# Access Compliance Report

## Public Rights-of-Way

### (Curb Ramps)

Intersection ID: 19496	Main Street: CRANFORD_DR	Cross Street: PARK_RD	Location: SW
ADA ID: 85884E524102	Ramp Type: Perp	Initial Pass/Fail: Fail	Overall Compliance: No
			Severity Score: 13.75

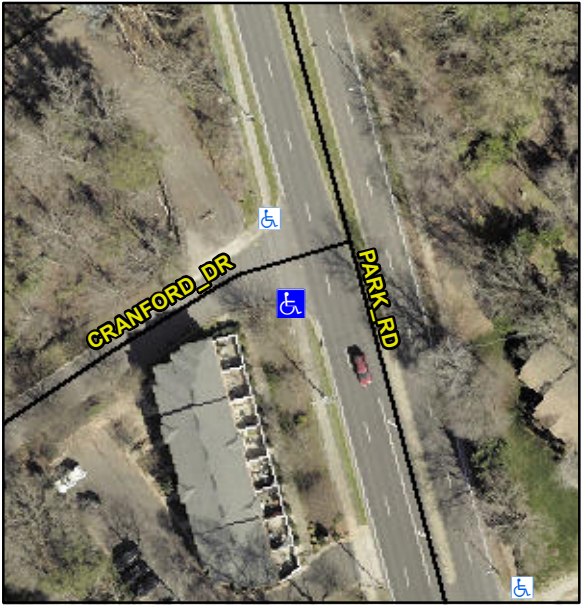
Codes/Mitigation Info/Possible Solution			Field Measurements/Component Compliance		
	Possible Solutions:		<b>Compliance</b>	<b>Description</b>	<b>Data</b>
	<b>Remove &amp; Replace Entire Ramp.</b>		<b>No</b>	Ramp Length (in)	71.0
			<b>Yes</b>	Ramp Width (in)	48.0
			<b>N/A</b>	Flare Type LT	N/A
			<b>N/A</b>	Flare Slope LT (%)	N/A
			<b>N/A</b>	Flare Traversable LT?	N/A
			<b>N/A</b>	Landing Length (in)	N/A
			<b>N/A</b>	Landing Width (in)	N/A
			<b>N/A</b>	Landing Slope (%)	N/A
			<b>N/A</b>	Landing X Slope (%)	N/A
<p>Surveyor Notes:</p> <p><b>N/A</b></p> <p>PROW/ADA:</p> <p><b>Not Found, R304.2.2, R304.5.3</b></p>			<b>N/A</b>	Flare Type RT	N/A
			<b>N/A</b>	Flare Slope RT (%)	N/A
			<b>N/A</b>	Flare Traversable RT?	N/A
			<b>N/A</b>	DWS Provided?	N/A
			<b>N/A</b>	DWS Contrast?	N/A
			<b>N/A</b>	DWS Length (in)	N/A
			<b>N/A</b>	DWS Full Width?	N/A
			<b>N/A</b>	DWS Offset (in)	N/A
			<b>N/A</b>	Shared Landing?	N/A

<b>N/A</b>	Gutter Ponding?	N/A
			<b>N/A</b>	Gutter Lip Ht (in)	N/A
			<b>N/A</b>	Painted X Walk1?	No
				X Walk 1 Direction	To N
			<b>N/A</b>	X Walk 1 Width (in)	N/A
				X Walk 1 Slope (%)	5.4
				X Walk 1 X Slope (%)	4.2
			<b>N/A</b>	Ramp inside XWalk1?	N/A
			<b>N/A</b>	Road Slope (%)	N/A
			<b>N/A</b>	Road X Slope (%)	N/A
			<b>N/A</b>	Any Obstructions?	N/A
Total Cost:		\$ 1850.00		Obstruction Type	
			<b>N/A</b>		
			<b>Yes</b>	Surface Condition? (G/P)	Good
